Access Compliance Report

Public Rights-of-Way

Intersection ID: N/A	Main Street: ALLEGIANCE DR	Cross Street: LADY LIBERTY LN	Location: NE
ADA ID: E7E2C9A21FFE	Ramp Type: PerpDiag	Initial Pass/Fail: Fail	Overall Compliance: No
		Severity Score: 10

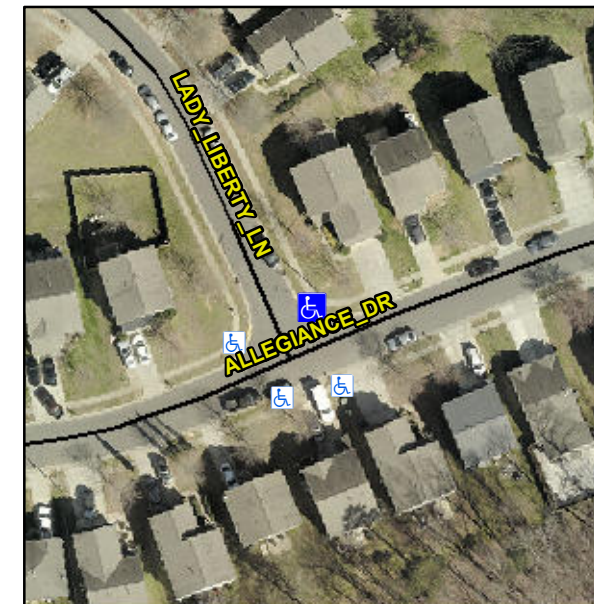
Not Found, R304.5.1, R304.5.3

Compliance	Description	Data	Compliance	Description	Data
N/A	Ramp Length (in)	49.0	Yes	Ramp Slope (%)	6.9
No	Ramp Width (in)	38.0	No	Ramp XSlope (%)	3.7
N/A	Flare Type LT	N/A	N/A	Flare Type RT	N/A
N/A	Flare Slope LT (%)	N/A	N/A	Flare Slope RT (%)	N/A
N/A	Flare Traversable LT?	No	N/A	Flare Traversable RT?	No
N/A	Landing Length (in)	N/A	N/A	DWS Provided?	N/A
N/A	Landing Width (in)	N/A	N/A	DWS Contrast?	N/A
N/A	Landing Slope (%)	N/A	N/A	DWS Length (in)	N/A
N/A	Landing X Slope (%)	N/A	N/A	DWS Full Width?	N/A
N/A	Landing Curb? (Y/N)	N/A	N/A	DWS Offset (in)	N/A
N/A	Shared Landing?	N/A			
N/A	Gutter Ponding?	N/A	N/A	Gutter Slope (%)	N/A
N/A	Gutter Lip Ht (in)	N/A	N/A	Gutter X Slope (%)	N/A
N/A	Painted X Walk1?	No	N/A	Painted X Walk2?	No
	X Walk 1 Direction	To W		X Walk 2 Direction	To S
N/A	X Walk 1 Width (in)	N/A	N/A	X Walk 2 Width (in)	N/A
	X Walk 1 Slope (%)	5.0		X Walk 2 Slope (%)	0.3
	X Walk 1 X Slope (%)	1.4		X Walk 2 X Slope (%)	4.0

Remove & Replace Curb Ramp With Two New Directional Ramps or Equivalent.
